Targeted Consultation Information Change Note

October 2025

We are inviting your feedback on a series of localised changes we are proposing to our plans for East Pye Solar.

East Pye Solar Limited, a subsidiary of Island Green Power (IGP) is bringing forward proposed plans for a utility scale solar farm and battery energy storage system (BESS) in South Norfolk (hereafter referred to as the Scheme). The Scheme comprises the construction, operation and maintenance, and decommissioning of a solar farm, with grid connection infrastructure including works to the existing 400kV overhead line and associated pylons.

Location of National Grid Substation

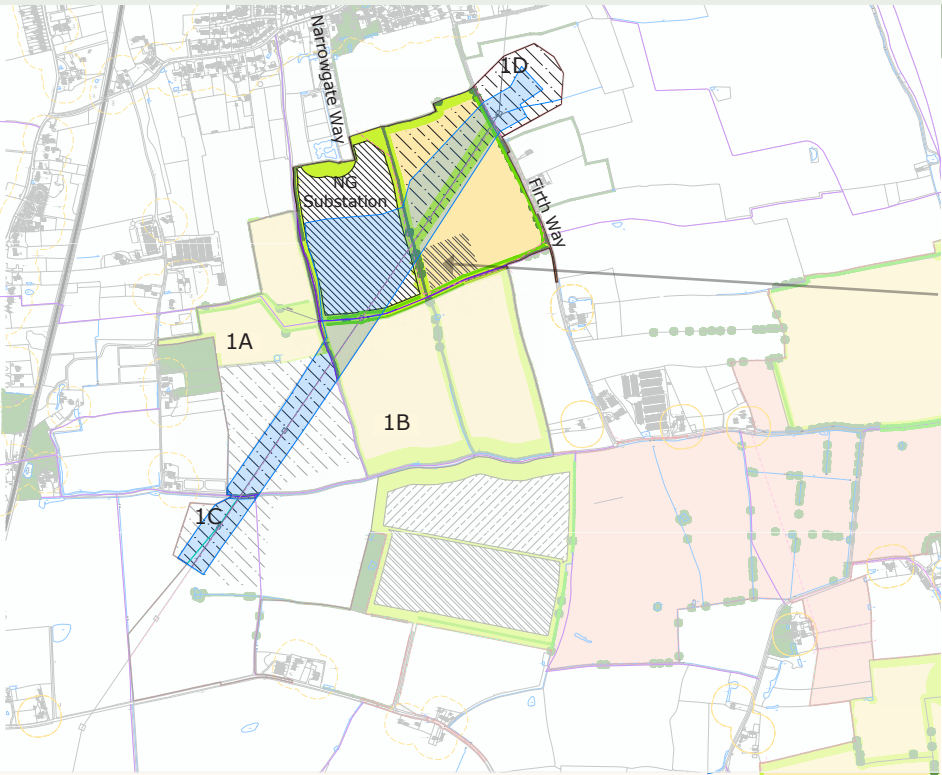
At the Phase Two statutory consultation, the Preliminary Environmental Information Report (PEIR) presented two options for the location of the new National Grid Substation - the 'National Grid Substation Site' (Option 1) and the 'National Grid Substation Option 2 Site' (Option 2 was situated within Site 1B).

Option 1 for the new National Grid Substation overlaps with the planning application (ref. 2024/3817) for a solar farm (Land to the North of Station Road), which received planning approval during the period of the Phase Two statutory consultation. As a result of this, together with the Option 2 location in Site 1B being preferable from a flood risk, heritage and landscape perspective compared to Option 1, Option 2 is the preferred location of the new National Grid Substation and has been taken forward.

Option 2 for the location of the new National Grid Substation is currently subject to design evolution. Option 1 is no longer being pursued as the location for the new National Grid Substation.

Additional land added to the Site Boundary Area to accommodate localised changes

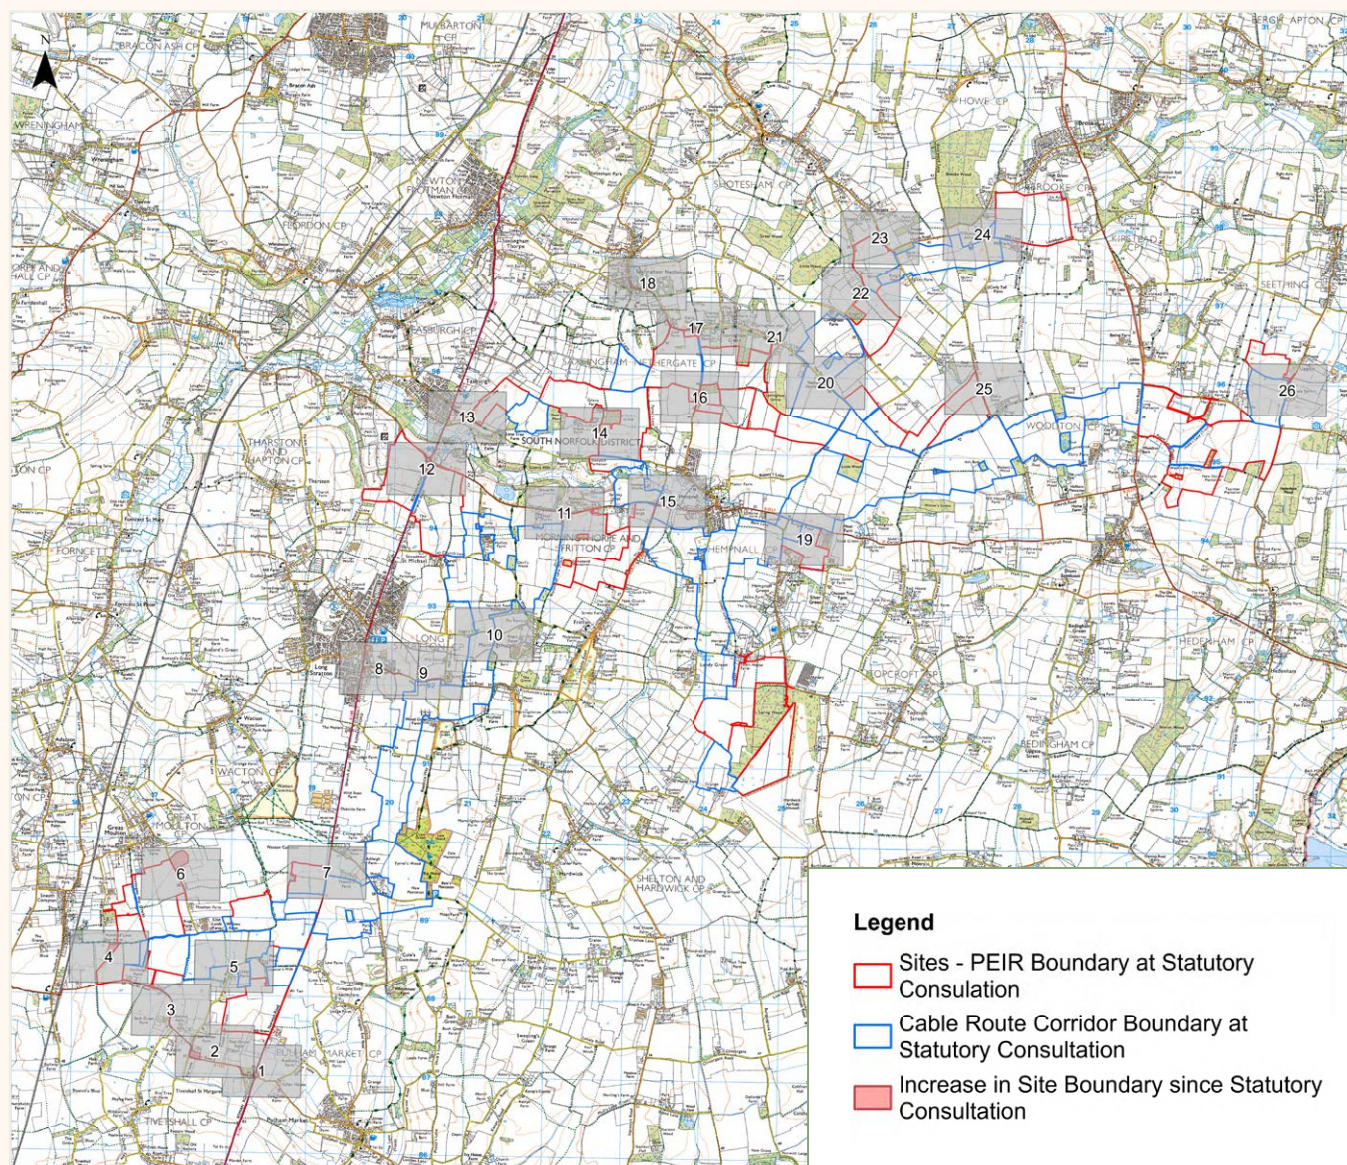
The plan below shows the location of the proposed changes to the Scheme boundary. These are numbered and further details can be found on the following pages.

B1134 Station Road / A140 Norwich Road Junction

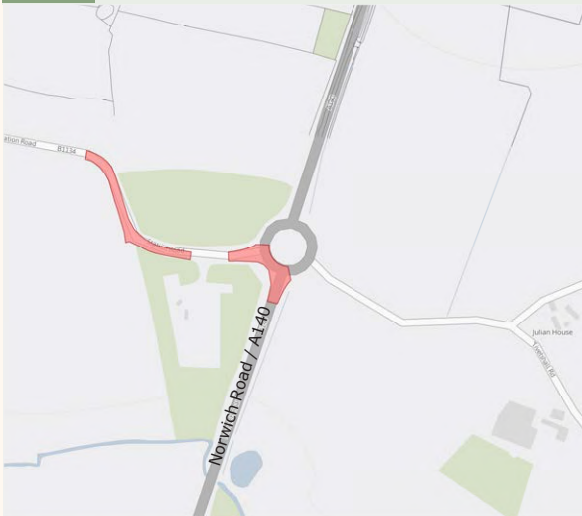
Description of change: The development boundary area has been increased to accommodate the potential for temporary removal of street furniture and vegetation removal. This will allow abnormal load vehicles to make the necessary turning movements.

Total area of change: 0.33 ha (0.81 acres)

B1134 Station Road between Prangle Lane and Lodge Road, including field to the North of B1134 Station Road

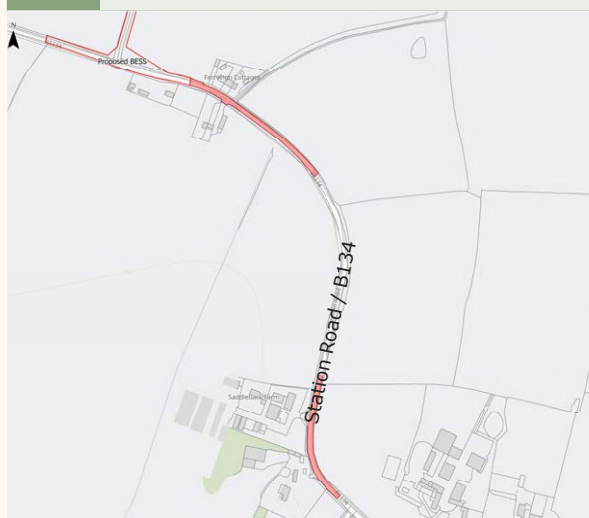
Description of change: The development boundary area has been increased to accommodate the potential for widening of the highway and vegetation removal. This will allow abnormal load vehicles to make the necessary turning movements.

Total area of change: 1.20 ha (3 acres)

Site 1C land to the west of (formerly) the National Grid Substation Site (Option 1) and South of Hundred Lane

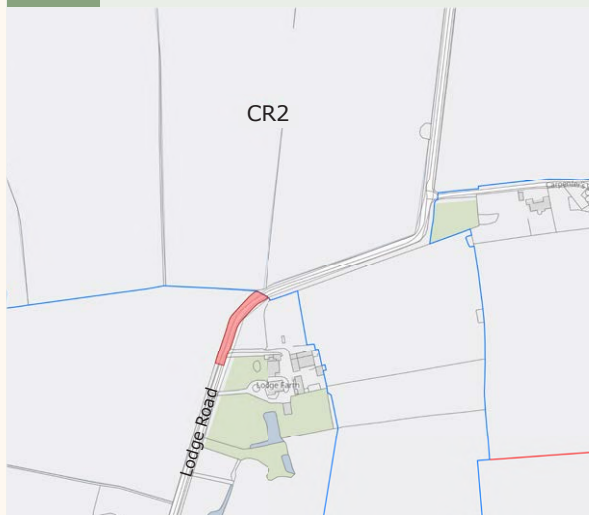
Why this was proposed: As part of the grid connection, required to carry out works to the existing overhead lines and the existing pylon to connect the new National Grid Substation in Site 1B to the existing overhead lines.

Description of change: Additional land to accommodate an area for netting, scaffolding and pulling zone to facilitate the restringing of the existing overhead lines.

Total area of change: 1.33 ha (3.29 acres)

North East of Site 1B / National Grid Substation Site (Option 2) and Frith Way

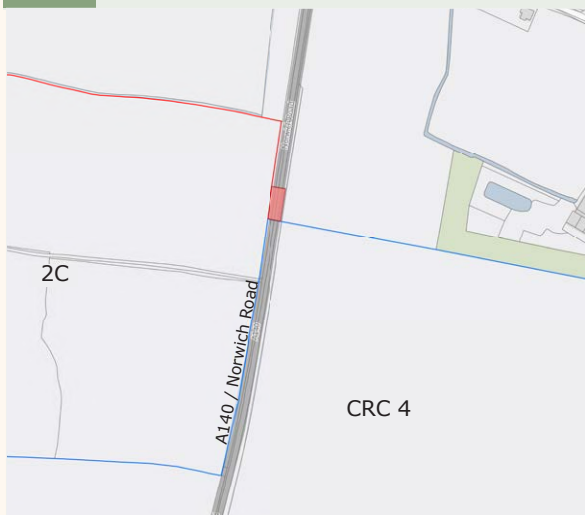
Why this was proposed: As part of the grid connection, it is required to carry out works to the existing overhead lines and existing pylon to connect the new National Grid Substation in Site 1B to the existing overhead lines and pylon.

Description of change: Additional land to accommodate an area for the netting, scaffolding and pulling zone to facilitate the restringing of the existing overhead lines and pylon.

Total area of change: 3.82 ha (9.44 acres)

A140 Norwich Road, South of Wood Lane

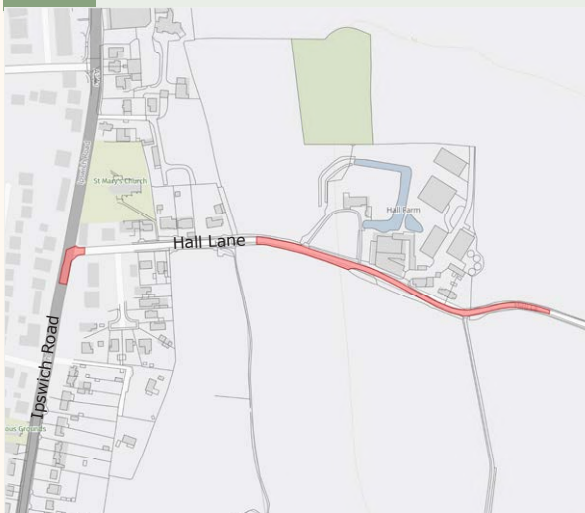
Description of change: The development boundary area has been increased to accommodate the potential vegetation removal along the highway. This will ensure there is sufficient visibility for vehicles to safely access the Site.

Total area of change: 0.04 ha (0.11 acres)

Hall Lane and Hall Lane / Ipswich Road Junction

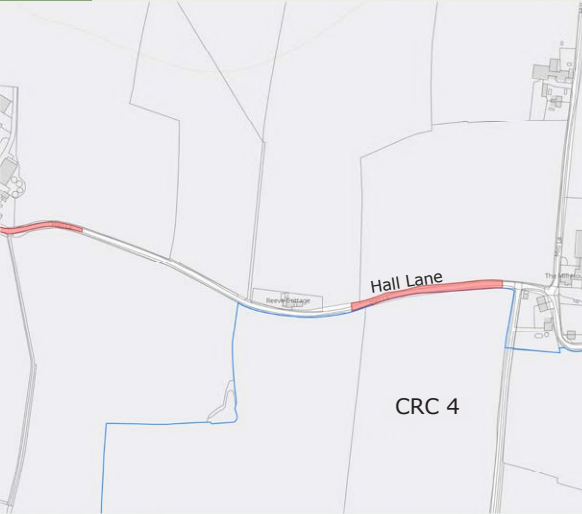
Description of change: The development boundary area has been increased to accommodate the potential for temporary removal of street furniture and vegetation removal. This will allow abnormal load vehicles to make the necessary turning movements.

Total area of change: 0.22 ha (0.54 acres)

Hall Lane Near Junction with Parker’s Lane

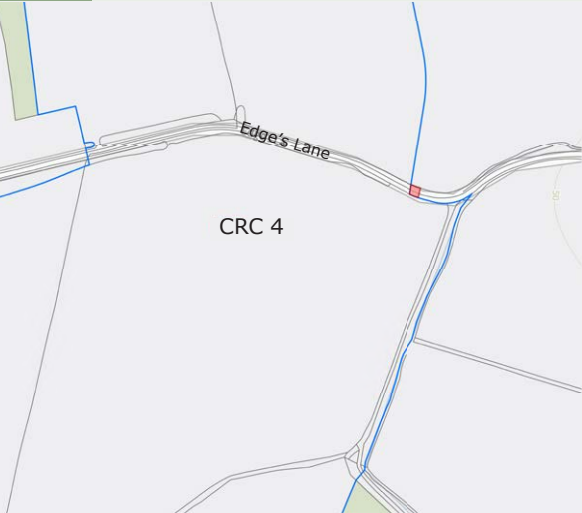
Description of change: The development boundary area has been increased to accommodate the potential for vegetation removal along the highway. This will ensure there is sufficient visibility for vehicles to safely access the Site.

Total area of change: 0.15 ha (0.37 acres)

Edge’s Lane, West of Harvey’s Lane

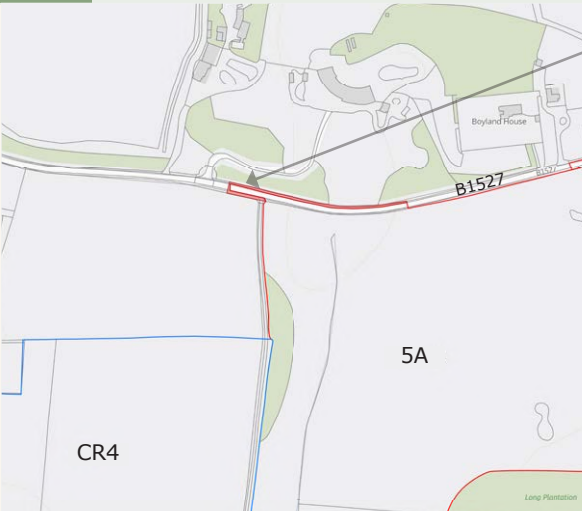
Description of change: The development boundary area has been increased to accommodate the potential for vegetation removal along the highway. This will ensure there is sufficient visibility for vehicles to safely access the Site.

Total area of change: 0.04 ha (0.01 acres)

B1527 Bungay Road

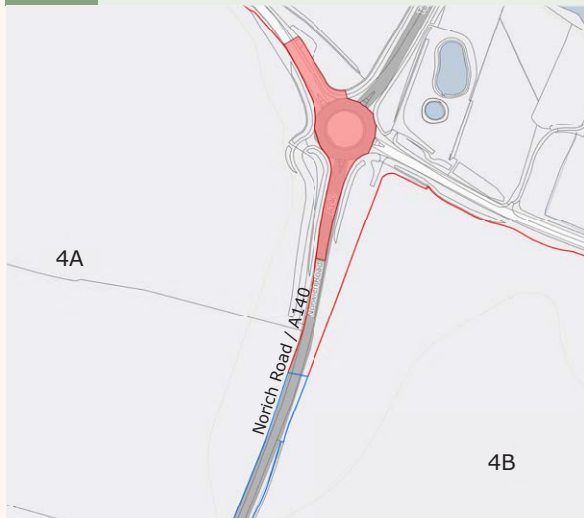
Description of change: The development boundary area has been increased to accommodate the potential for vegetation removal along the highway. This will ensure there is sufficient visibility for vehicles to safely access the Site.

Total area of change: 0.05 ha (0.13 acres)

A140 Hempnall Roundabout

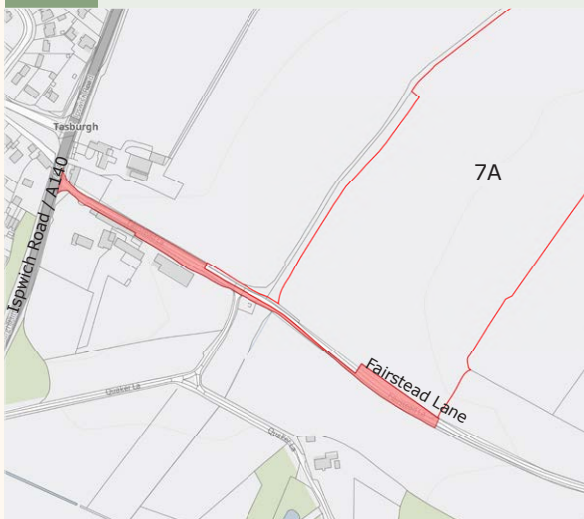
Description of change: The development boundary area has been increased to accommodate the potential for temporary minor alterations to the Site access junction arrangement and vegetation removal along the highway. This will ensure there is sufficient visibility for vehicles to safely access the Site.

Total area of change: 0.45 ha (1.10 acres)

Fairstead Lane and Junction with A140 Tasburgh Hill / Ipswich Road

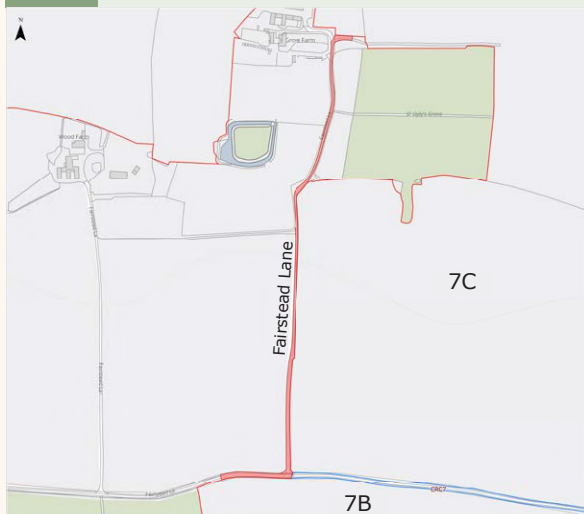
Description of change: The development boundary area has been increased to accommodate the potential for areas of vegetation removal along the highway. This will ensure there is sufficient visibility for vehicles to safely access the Site.

Total area of change: 0.35 ha (0.86 acres)

B1527 Bungay Road / The Krons / The Street Junction

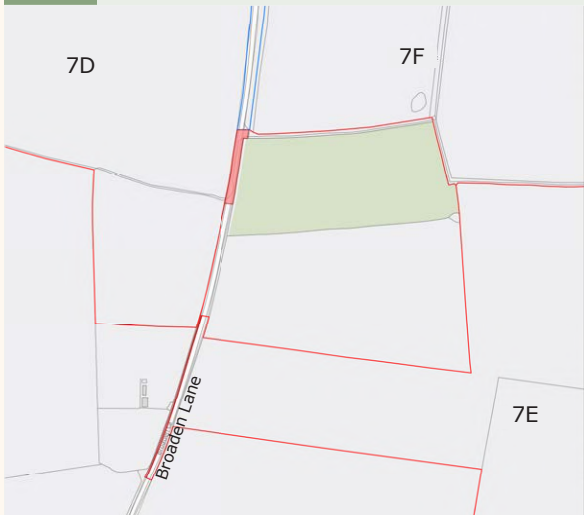
Description of change: The development boundary area has been increased to accommodate the potential for areas of vegetation removal along the highway. This will ensure there is sufficient visibility for vehicles to safely access the Site.

Total area of change: 0.02 ha (0.04 acres)

Church Lane / Broaden Lane between Plummer's Lane and The Green

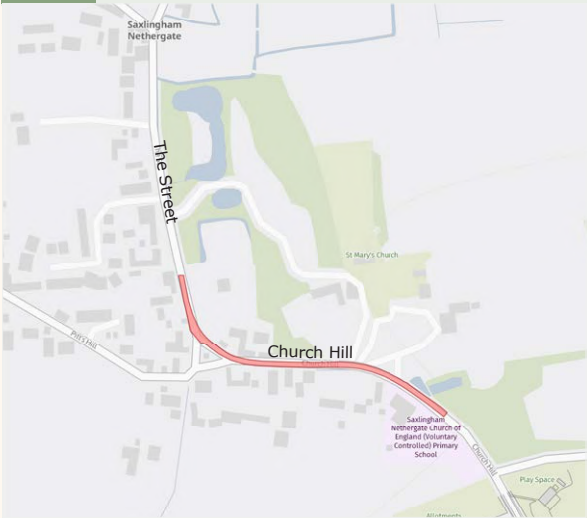
Description of change: The development boundary area has been increased to accommodate the potential for temporary removal of street furniture and vegetation removal. This will allow an abnormal load vehicle to make the necessary turning movements.

Total area of change: 0.21 ha (0.53 acres)

The Street / Church Hill, Saxlingham Nethergate

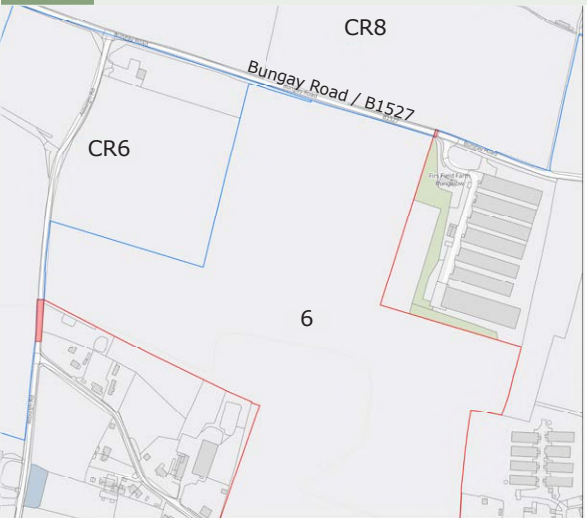
Description of change: The development boundary area has been increased to accommodate the potential for temporary removal of street furniture and vegetation removal. This will allow an abnormal load vehicle to make the necessary turning movements.

Total area of change: 0.18 ha (0.44 acres)

Alburgh Road, South of Back Lane and North of Hempnall Green

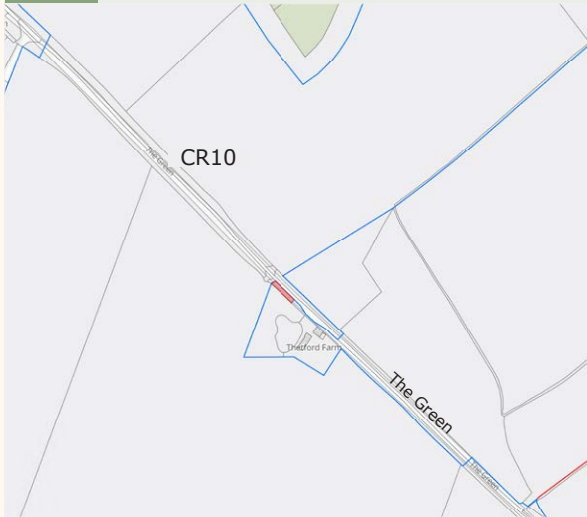
Description of change: The development boundary area has been increased to accommodate the potential for areas of vegetation removal along the highway. This will ensure there is sufficient visibility for vehicles to safely access the Site.

Total area of change: 0.04 ha (0.11 acres)

The Green, East of Saxlingham Green

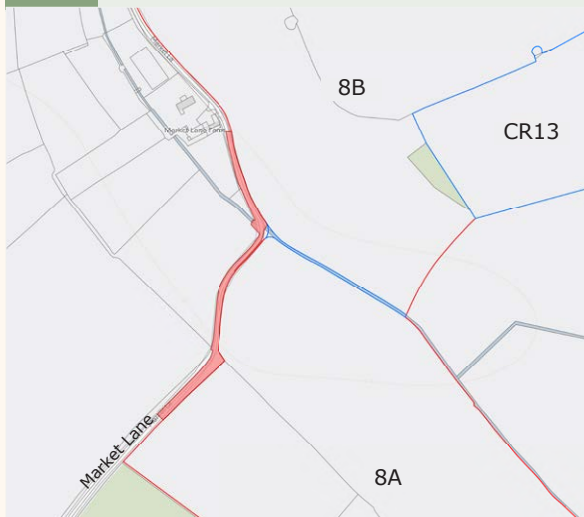
Description of change: The development boundary area has been increased to accommodate the potential for areas of vegetation removal along the highway. This will ensure there is sufficient visibility for vehicles to safely access the Site.

Total area of change: 0.004 ha (0.01 acres)

Market Lane

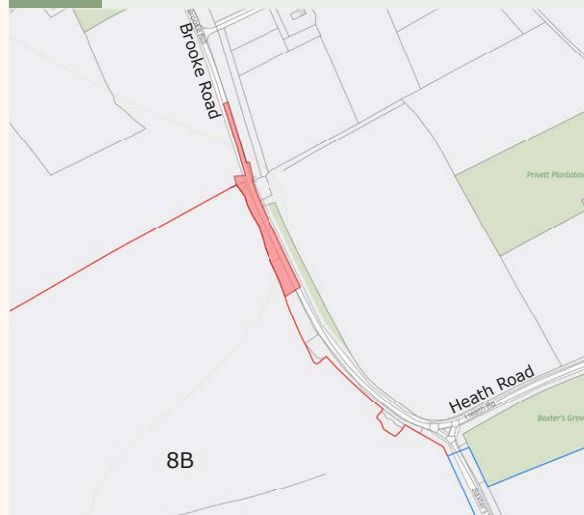
Description of change: The development boundary area has been increased to accommodate the potential for areas of vegetation removal along the highway. This will ensure there is sufficient visibility for vehicles to safely access the Site.

Total area of change: 0.26 ha (0.63 acres)

Woodton Road Near Junction with Mill Lane

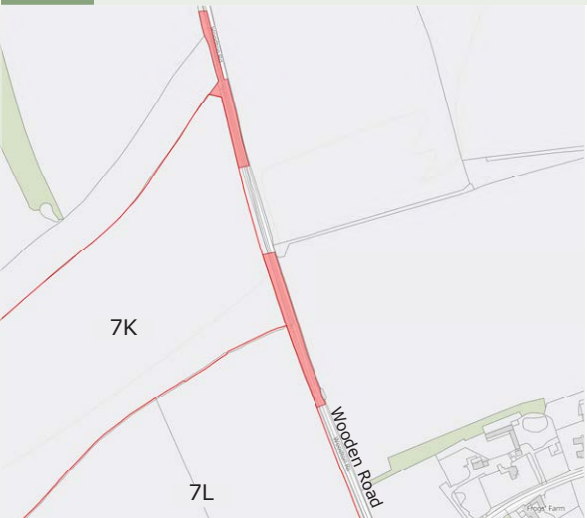
Description of change: The development boundary area has been increased to accommodate the potential for areas of vegetation removal along the highway. This will ensure there is sufficient visibility for vehicles to safely access the Site.

Total area of change: 0.01 ha (0.03 acres)
